Process Change Notice – PCN040317-01

Description of Change
Change to a lower viscosity epoxy material to allow the use of an automated machine instead of a manual application

The gray epoxy material added and cured on the motor rotor just prior to turning operation

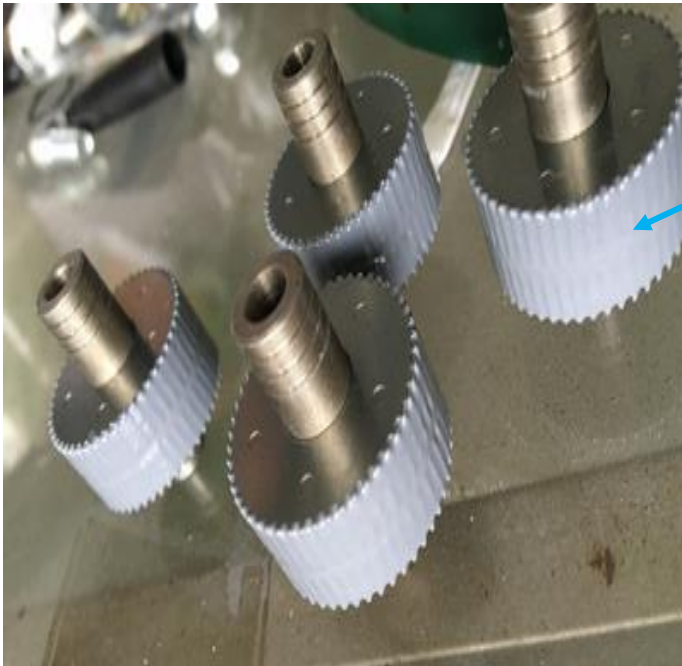
The subject material is illustrated in the photo below. During motor manufacturing, a gray epoxy is added to the outside of the magnetic rotor to aid in a final turning process of the rotor using a grinding machine. The gray epoxy is added to allow steel chips to cleanly "sheer" from the surface of the individual rotor teeth. The epoxy is used to aid in the manufacturing process only, and serves no purpose in the performance or structural integrity of the final product.

Appearance After Manual Application Using Existing Epoxy Material

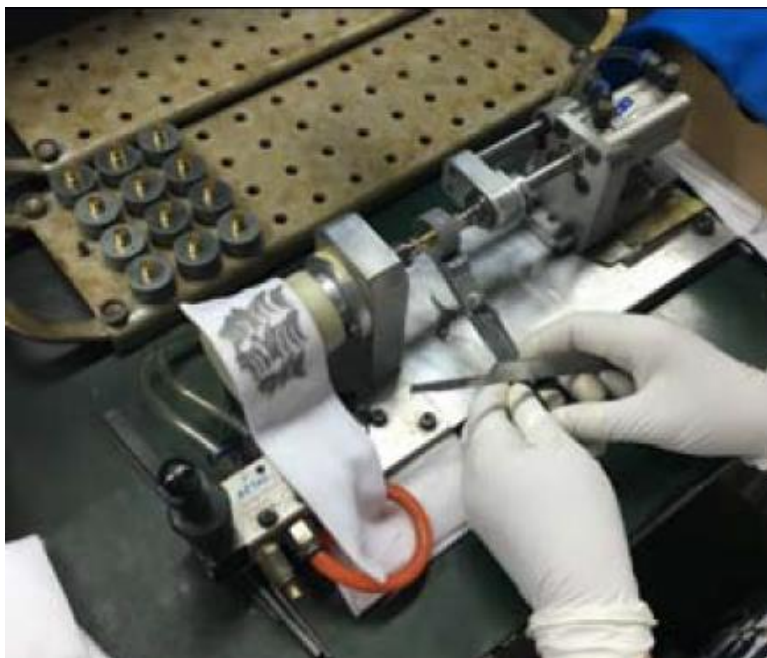
The current process requires that the gray epoxy be spread onto the motor rotor just prior to curing. This is a manual process requiring the operator to add the material using a brush applicator. The new process will use an automated application machine that will increase throughput, allow higher product consistency, and result in less wasted material. Due to the operation of the automated application machine, the epoxy needed to be changed from Loctite E214-HP to Loctite E214-HP-1. The new material is a lower viscosity material that is more compatible with an automated application process. Comparison photos can be seen below.
